RE: North Penn High School BP-2
Change Order Request #31 ASI 08 & ASI 18 – Door Hardware Changes

ARCHITECT'S SUPPLEMENTAL INSTRUCTIONS (ASI) 08
DOOR SCHEDULE REVISIONS

ARCHITECT'S SUPPLEMENTAL INSTRUCTIONS (ASI) 18
DOOR HARDWARE REVISIONS

North Penn School District
North Penn High School Renovations
Bid Package 2

Drawing Number:
BP2-SKA-003

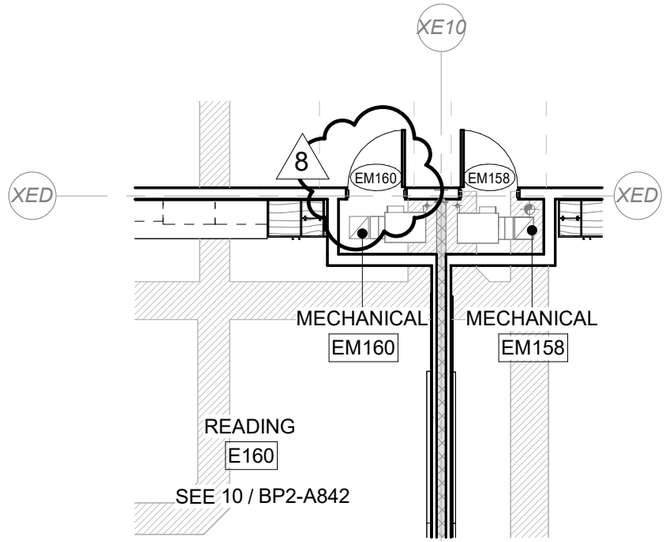
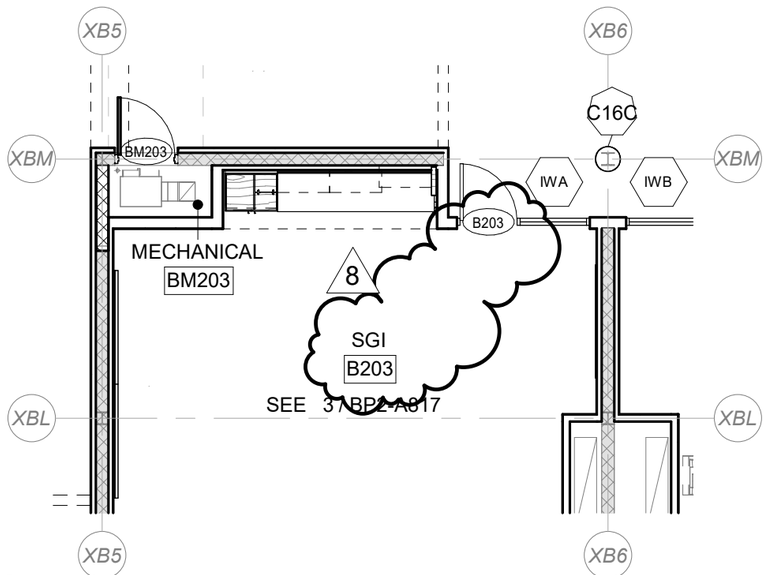
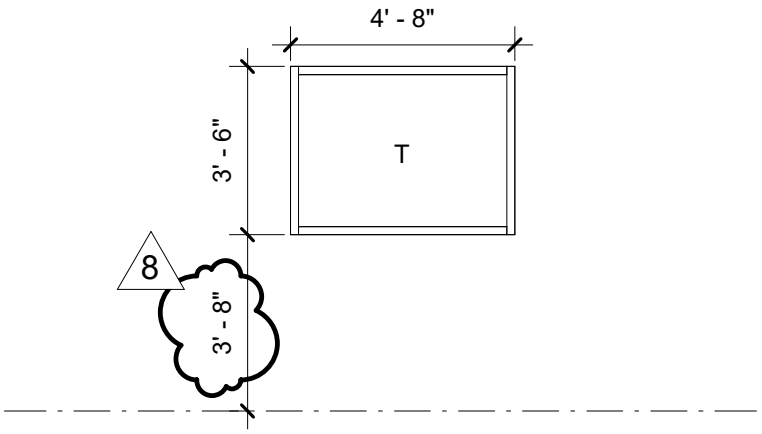
8.05 Sketch BP2-SKA-003; ADD sketch BP2-SKA-003 dated 06/08/2026.
8.06 Sketch BP2-SKA-004; ADD sketch BP2-SKA-004 dated 06/08/2026.

Sketches - Architectural:
BP2-SKA-003 DOOR SWING REVISIONS
BP2-SKA-004 STOREFRONT SILL HEIGHT REVISION
